## Product Update

Changes have been made to the CV3106-01 Drive Bracket. These enhancements were prompted by customer feedback and feature some minor structural modifications to the drive bracket assembly. We have outlined the specific changes to the bracket below.

The new part number for this assembly is CV3002-A. This part includes the upgraded drive bracket, spring clip, drive gear cover, and drive reducing gears.

New Drive Bracket Assembly

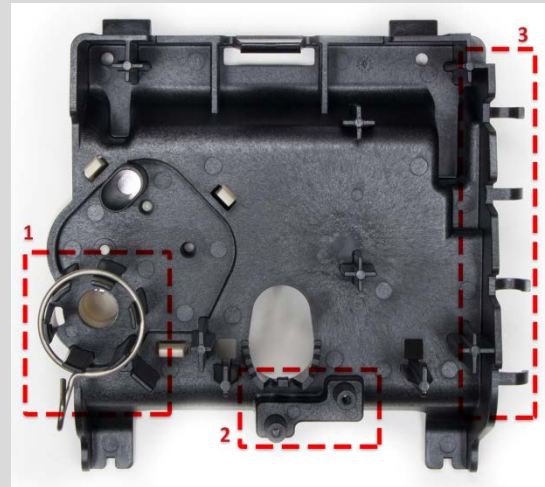
1. Slot spacing for the motor has been widened, offering more flexibility for motor installation.
2. An enhanced support base for micro-switch mounting posts has been added on the bottom to eliminate flexing of the assembly.
3. The right side wall has been lowered. This allows for better fits for Molex connectors and prevents connectors from bending after coming in direct contact with the side wall.
